TIERRA ROBLES

PLANNED DEVELOPMENT

Final Environmental Impact Report

NOVEMBER 2021

TIERRA ROBLES PLANNED DEVELOPMENT • EIR
Composite Parcel Map
 Figure 5.10-1

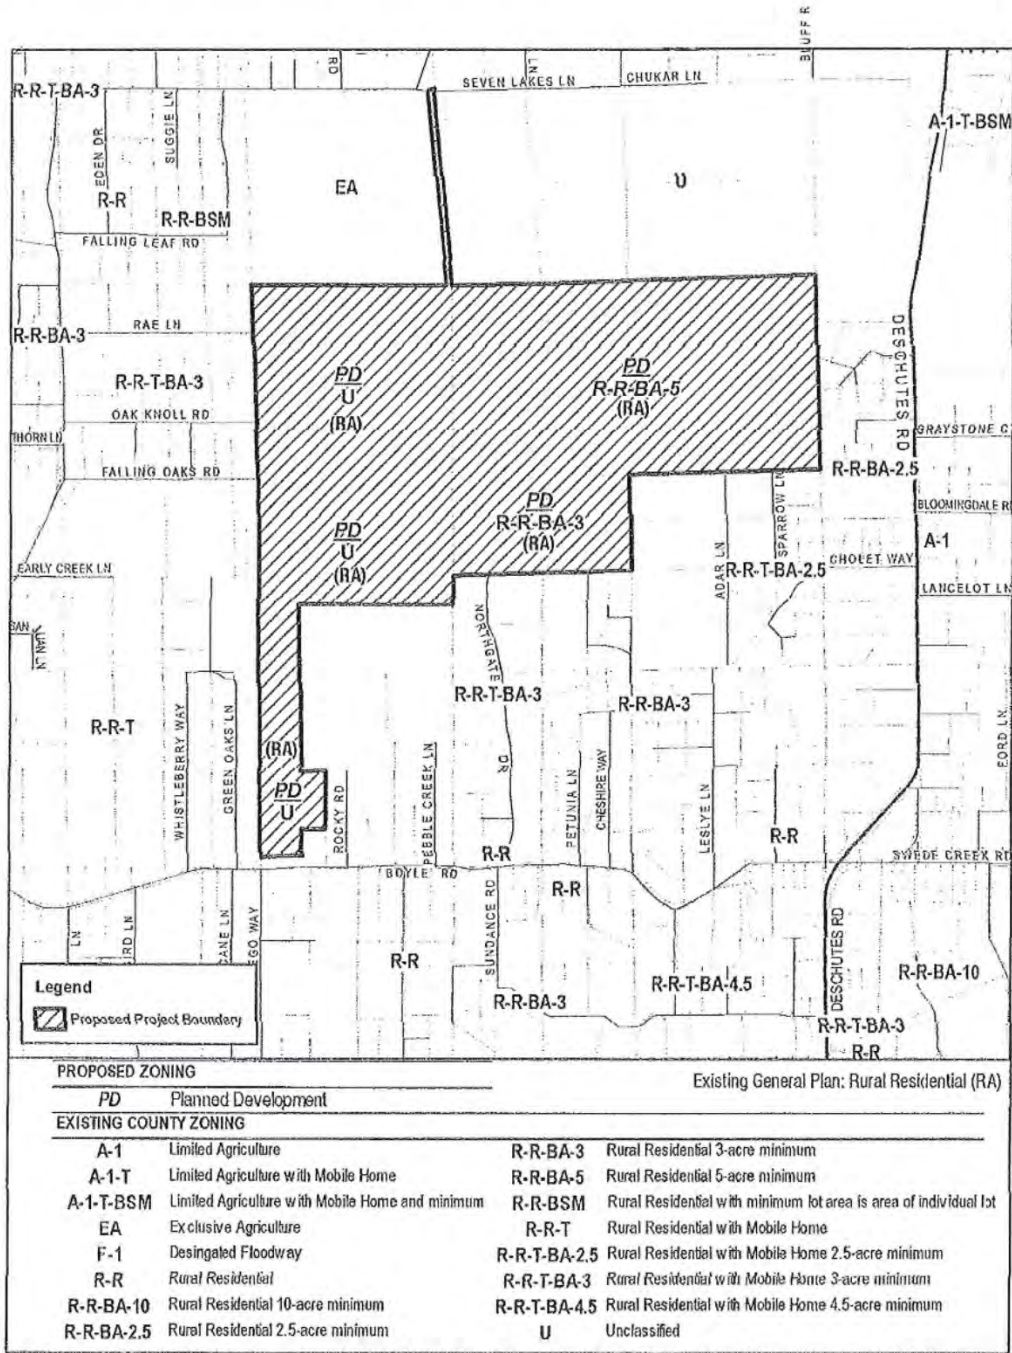
The chart below combines and compares Table 3-4 "Project Acreage and Lotting Summary" on page 3-16 of the Subdivision Development Summary to the number and percentage of parcel acreages from the Composite Parcel Map Figure 5.10-1:

Proposed Mitigation: Since the above chart shows that the proposed zoning amendment change for a Planned Development is not consistent with the existing parcel zoning in the surrounding area, the following Alternative Plan shall be adopted: The Developer shall be required to convert the proposed 471.92 usable acres to a number of lot parcels that mimic the exact percentages of the surrounding parcels as depicted in Composite Parcel Map Figure 5.10-1, *with the exception of parcel sizes that fall below 2 acres* since the rural residential zoning require one dwelling per 2 acre minimums. If not, then the Developer should not be granted a zoning amendment for a Planned Development.

Response 65-q: The commenter restates that the proposed project is not consistent with the Shasta County General Plan or the County Zoning Ordinance and has no correlation to the surrounding rural community. The commenter suggests that the developer convert the usable acres of the project site to a number that mimics the exact percentage of the surrounding parcels as depicted in Figure 5.10-1, with the exception of parcel sizes that fall below two acres.
